Product Equality Declaration

We, Motorola Mobility LLC. declare on our sole responsibility for the product of Super row SKU(FCC ID: IHDT56XR2) and Brazil & Latam SKU(FCC ID: IHDT56XR3), the detail differences as below:

3. Band circuit

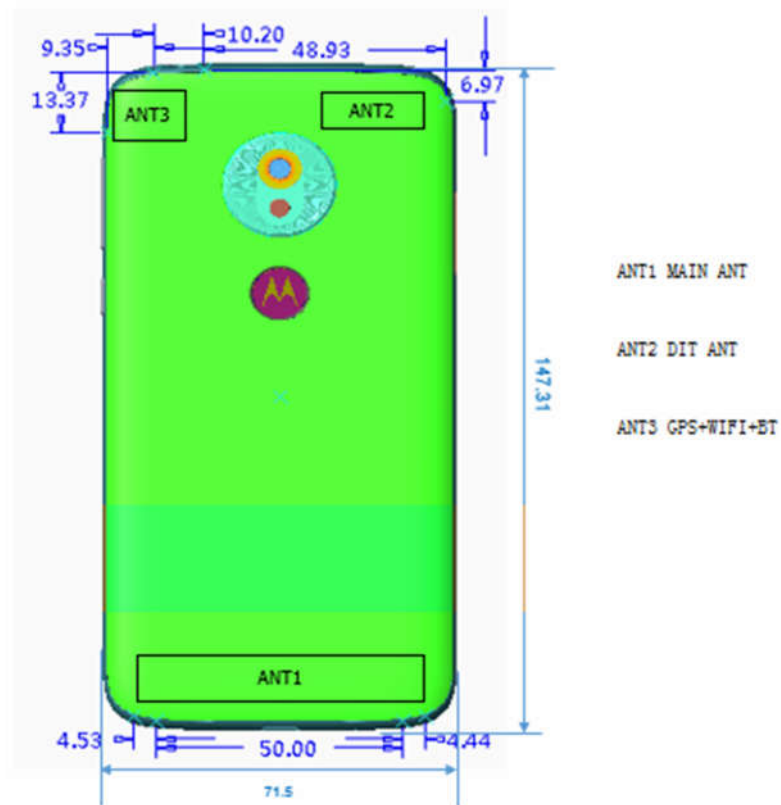
Commodity	Brazil & Latam SKU	Super row SKU	Vendor Part number
B1 Duplexer(1814)	1	1	SAYRH1G95BA0F0A
B2 Duplexer(1814)	1	1	SAYEY1G88BC0B0A
B3 Duplexer(1814)	1	1	SAYEY1G74BC0B0A
B4 Duplexer(1814)	1	1	D6DA2G132K2D4
B5 Duplexer(1814)	1	1	SAYEY836MBE0F0A
B7 Duplexer(1814)	1	1	D6HQ2G655DP02
B8 Duplexer(1814)	1	1	SAYEY897MBA0B0A
B20 Duplexer(1814)	0	1	D5FC847M0K3NE
B28A Duplexer(1814)	1	1	B8538
B28B Duplexer(1814)	1	1	B8539
B40 TRX_SAW(1109)	0	1	885075
B40 DRX SAW(1109)	0	1	SFHG52AA002
B41 (120M) TRX SAW(1109)	0	1	B8870
B41 (120M) DRX SAW(1109)	0	1	SFHG96AA402
B3&7 DRx dual_SAW(1511)	1	1	SAWFD1G84AG1F0A
B25+66_RX Dual Saw_1511	1	1	SAWFD1G96AC2F0A
B5 DRx SAW(1109)	1	1	MS11U881M-RX05S
B8 DRX SAW(1109)	1	1	MS11U942M-RX08S
B20 DRX SAW(1109)	0	1	SFH806BA002
B28 DRX SAW(1109)	1	1	SFH780AA402
Diplexer for GPS/2.4G WIFI	1	1	RFDIP1608060T97Q1C
GPS SAW(1109)	1	1	SFDG89JA402

2.4G WIFI SAW(1109)	1	1	F6HG2G441EG65
SP3T (TX)	1	1	MXD8638C
SP8T(Diversity ASM)	0	1	MXD8680
B66 Duplexer(1814)	1	0	D6DA2G155K2T2
SP6T(Diversity ASM)	1	0	MXD8661
